Reliability Analysis Update

Transmission Expansion Advisory Committee
May 6, 2025

Scope Change & Cost Updates Baseline Reliability Projects

Scope Change for b3800.360

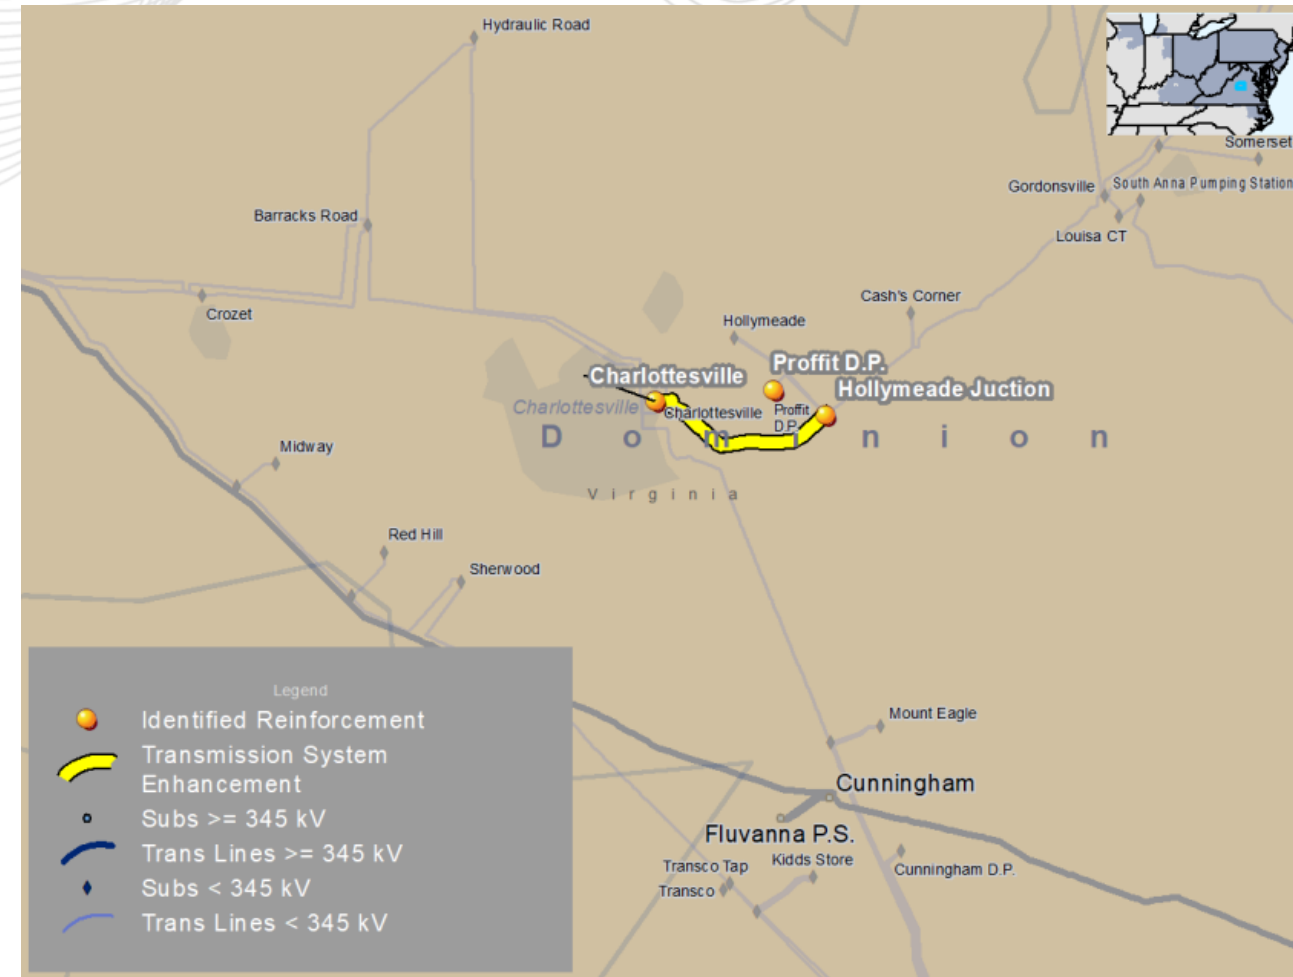
Wreck/Rebuild 230kV Line #2054 segment Charlottesville – Hollymeade Junction using double-circuit capable 500/230 kV poles. (The 500kV circuit will not be wired as part of this project.)

Wreck/Rebuild 230kV Line #2054 segment Charlottesville – Hollymeade Junction using double-circuit capable 230 kV poles. (The second 230kV circuit will be wired but not have terminal ends.)

Due to Right-of-Way restrictions, Dominion is proposing to build double-circuit 230/230kV structure.

Revised Cost Estimate: ~~\$70.14 M~~ **\$46.53 M**

Revised Projected IS Date: ~~6/1/2028~~ **12/1/2028**

Scope Change for b3800.300 & b3800.301

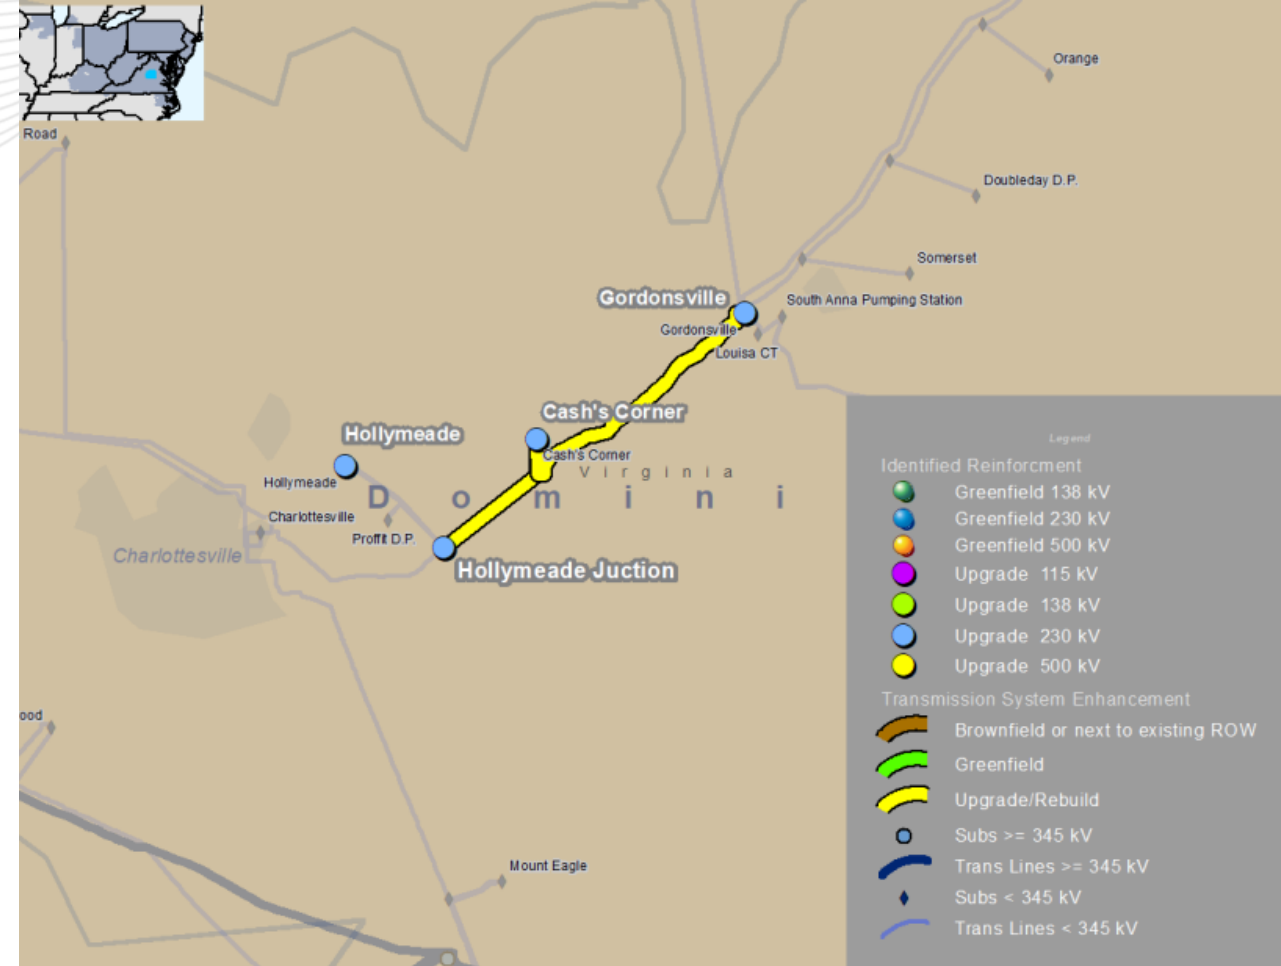
- Wreck/Rebuild 230kV Line #2135 segment Hollymeade Junction – Cash's Corner using double-circuit capable 500/230 kV poles. (the 500kV circuit will not be wired as part of this project). **b3800.300**
- Wreck/Rebuild 230kV Line #2135 Cash's Corner – Gordonsville using double-circuit capable 500/230 kV poles. (the 500kV circuit will not be wired as part of this project). **b3800.301**

- Wreck/Rebuild 230kV Line #2135 segment Hollymeade Junction – Cash's Corner using double-circuit capable 230 kV poles. (The second 230kV circuit will be wired but not have terminal ends.) **b3800.300**
- Wreck/Rebuild 230kV Line #2135 Cash's Corner – Gordonsville using double-circuit capable 230 kV poles. (The second 230kV circuit will be wired but not have terminal ends.) **b3800.301**

Due to Right-of-Way restrictions, Dominion is proposing to build double-circuit 230/230kV structure.

Revised Cost Estimate: ~~\$53.96 M~~ **\$36.0 M**

Scope Change for b3800.304

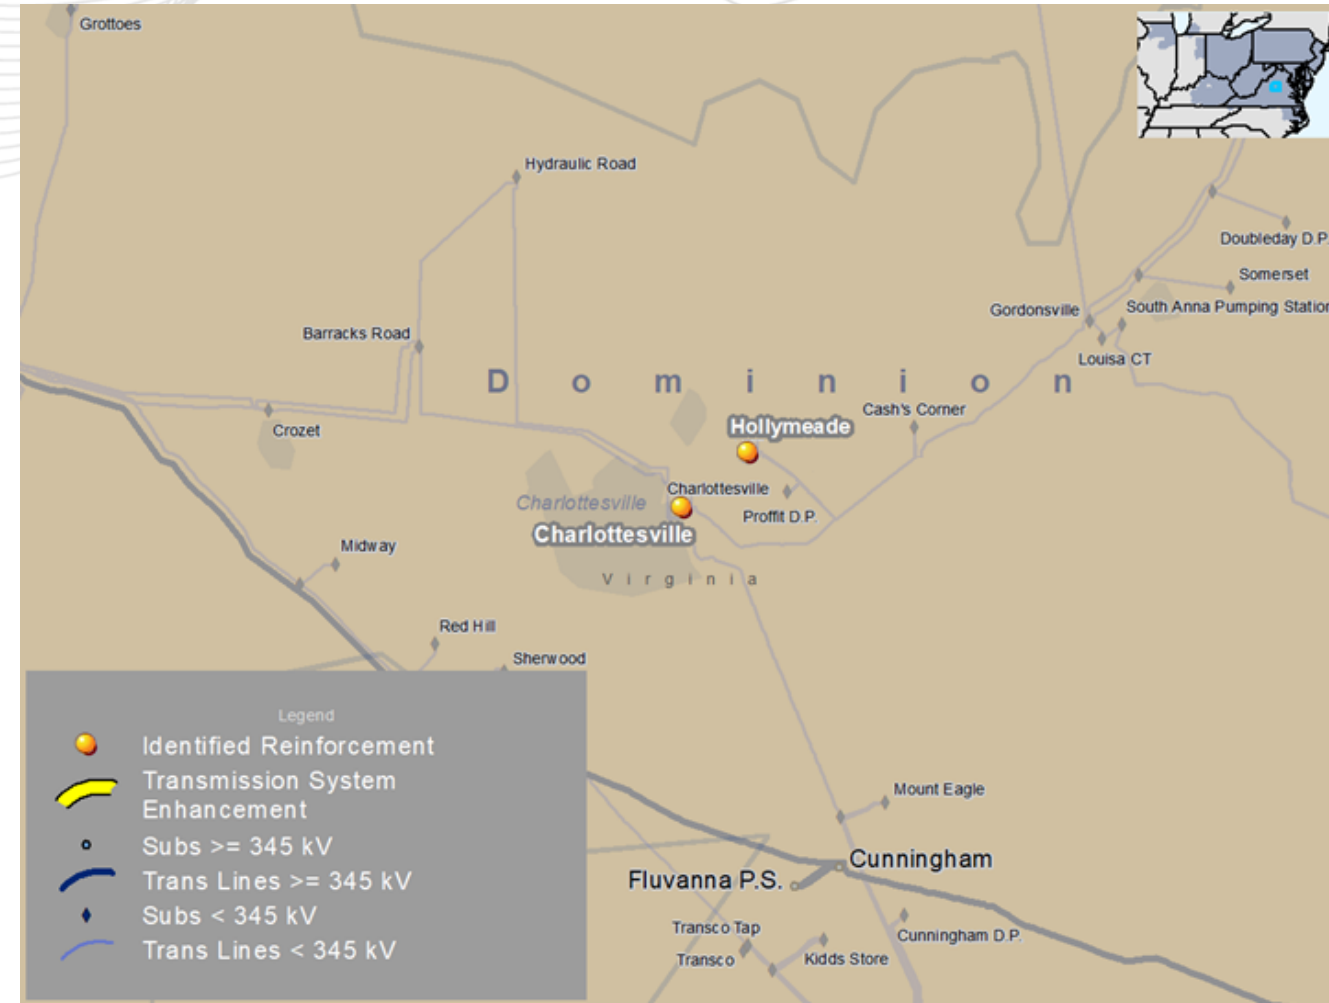
Upgrade Hollymeade substation switch 213549 and line leads to 4000A continuous current rating of 230 kV line No. 2135.

Upgrade Charlottesville substation switch 205415 and line leads to 4000A continuous current rating of 230 kV line No. 2054.

The Hollymeade substation switch 213549 rating is sufficient to not limit 230 kV line No. 2135. Charlottesville substation switch 205415 is being upgraded to not limit 230 kV line No. 2054.

Cost Estimate: \$0.3 M

Projected IS Date: ~~6/1/2028~~ 12/30/2028

Scope Change for b3692 (500kV Line Elmont – Chickahominy):

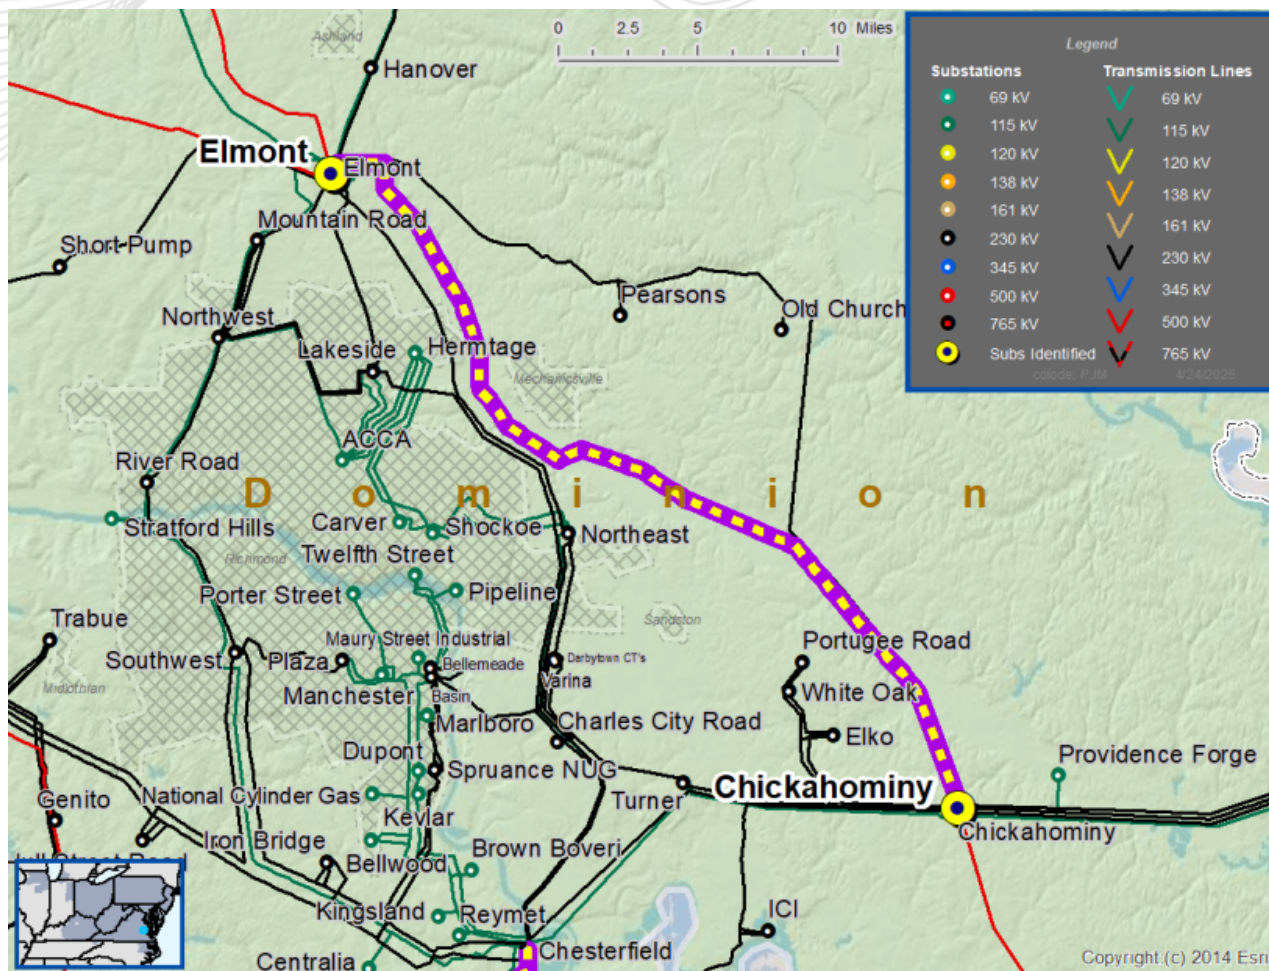
Rebuild approximately 27.7-miles of 500 kV transmission line from Elmont to Chickahominy with current 500 kV standards construction practices to achieve a summer rating of 4330 MVA.

Revised Solution for b3692 (500kV Line Elmont – Chickahominy):

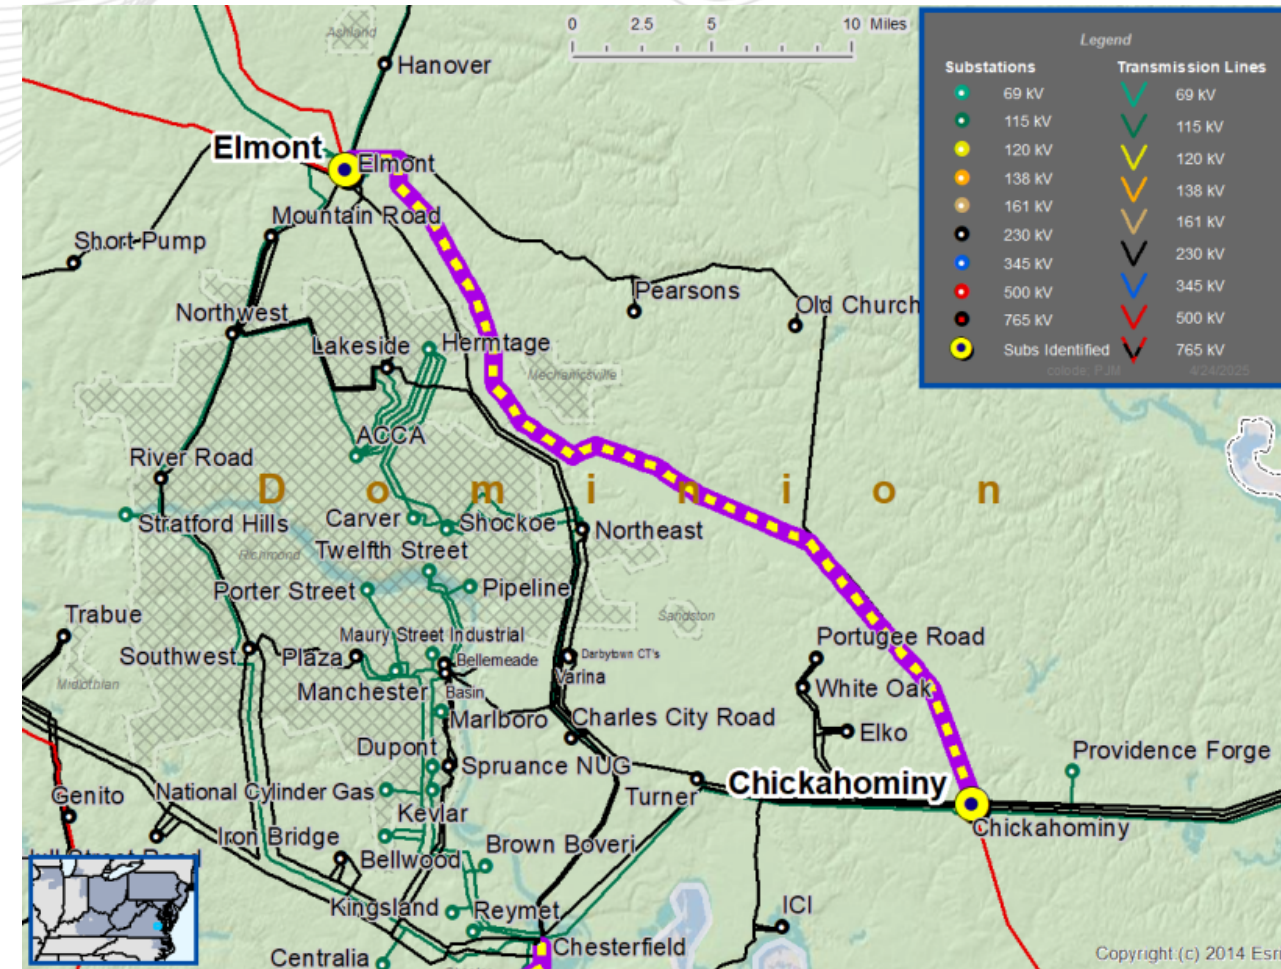
Structure change from lattice structures to H-frame structures for the whole span of the transmission line.

Transmission ROW contains approximately 8 miles of heavy swamp terrain that requires additional materials for access increasing construction costs. In addition, inflation between 2021 & 2023 timeframes increased material costs.

Additional Cost Estimate: \$52.5 M

Revised Cost Estimate: \$110.66 M

Revised In-Service Date: 6/30/2028

Additional 230kV Scope for b3692 (500kV Line Elmont – Chickahominy):

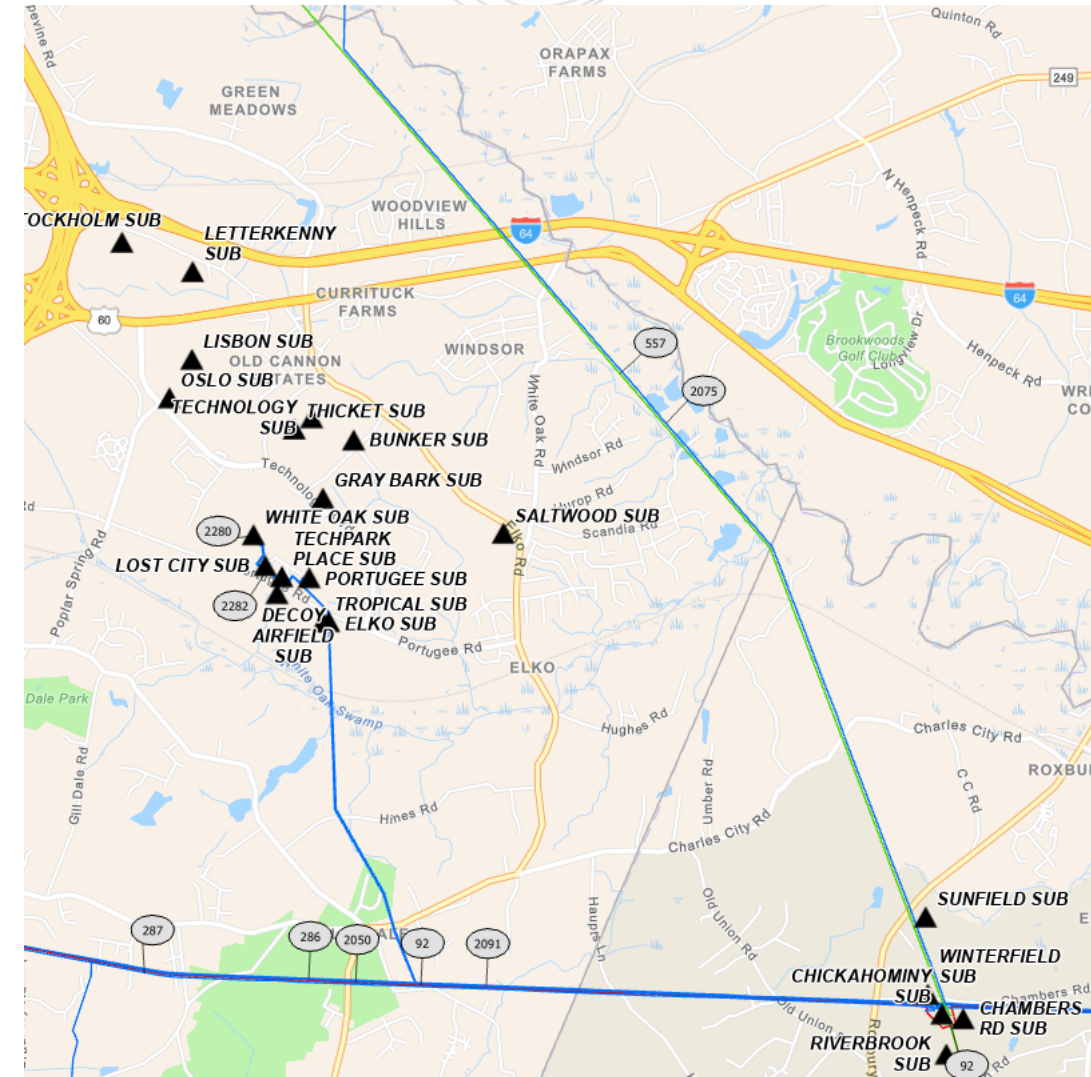
Switch to 5/2 H-frame structures and install approximately 27.7 miles of 230kV transmission line (but not be terminated) from Elmont to Chickahominy. String up approximately 8 miles of new 230kV conductor on the open arms of the structures of 230kV Line #2075 that runs parallel to 500kV Line #557.

The general area within proximity of the Line #557 Elmont-Chickahominy rebuild has received approximately 15 Delivery Point requests, mainly data centers, since proposing this project during the 2021 RTEP Open Window 1.

Since Line #2075 runs parallel to Line #557 in the same ROW corridor, the 8 mile portion that runs through the heavy swamps will be strung up with new 230kV conductor on the open arms of the structures for Line #2075 for future use. This will minimize future environmental impacts and construction costs due to the challenges of the swampy terrain in this ROW.

Total Proposed Cost Estimate: \$185.16 M (increase of \$127 M)

Revised In-Service Date: 6/30/2028

Scope Change for b4000.207

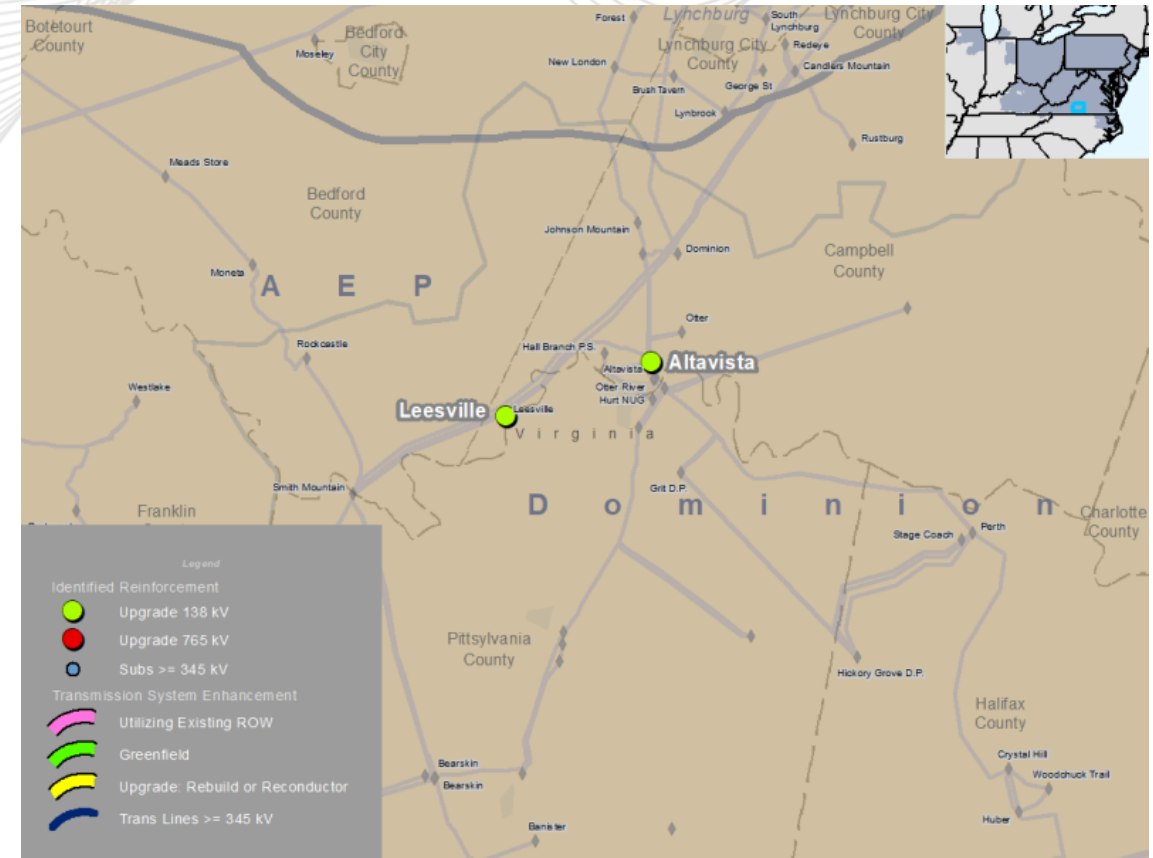
- (AEP) Leesville 138kV Station Upgrade: Replace 795 KCM AAC, 37-Str. IPS Sch. 40 1272 KCM AAC, 61-Str. 1272 KCM AAC, 61-Str. PH A,B,C ALTA VISTA CB-A BUS DISC ALTA VISTA CB-A LINE DISC Wavetrapp (1200A) Relay Thermal Limit 1356 Amps (b4000.207) Estimated Cost: \$0.6 M
- (DOM) Altavista 138kV Station Upgrade: Replace two switches, a wave trap and leads to upgrade all related substation equipment to 2000A. (b4000.360) Estimated Cost: \$1.0 M

- Upgrades required on the Dominion side of the tie line to achieve proposed rating.

Total Estimated Cost: ~~\$0.6 M~~ 1.6 M
